550 HALEKAUWILA RENOVATIONS

RFP NO. SOHHS-RFB-2026-01

Question & Answer

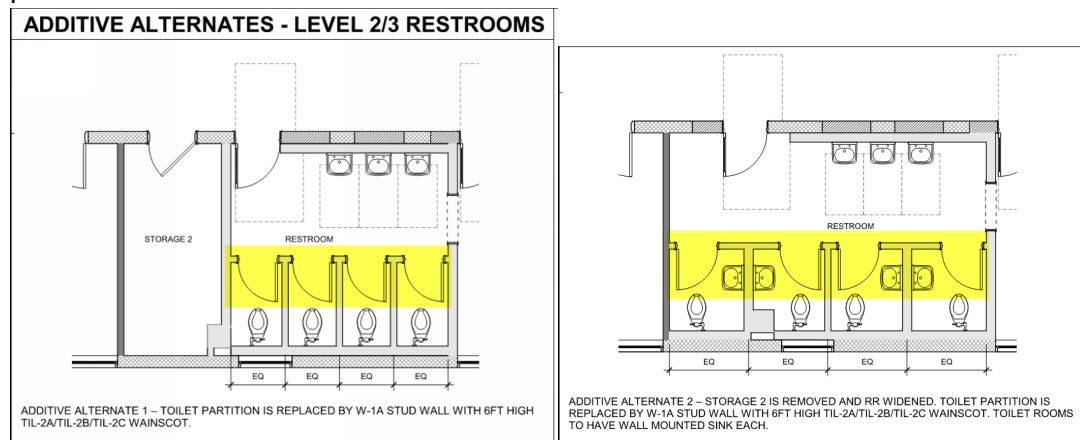
36. Please clarify what the Exterior Note #5 on A201 means, what is the scope of work intended and where does it apply? Note: RESTORE WINDOWS TO FULL

DIMENSIONS WHERE PREVIOUSLY COVERED, EXCEPT FOR WHEN WINDOWS ARE SHOWN AS HIDDEN BY WALL IN NEW CONSTRUCTION PLANS.

Response: *The intent of the note is to restore existing windows that have been partially covered over time to their original full opening. Contractor shall identify all such conditions and prep as necessary to restore the windows, unless the drawings specifically indicate that a window is to remain concealed by new construction.*
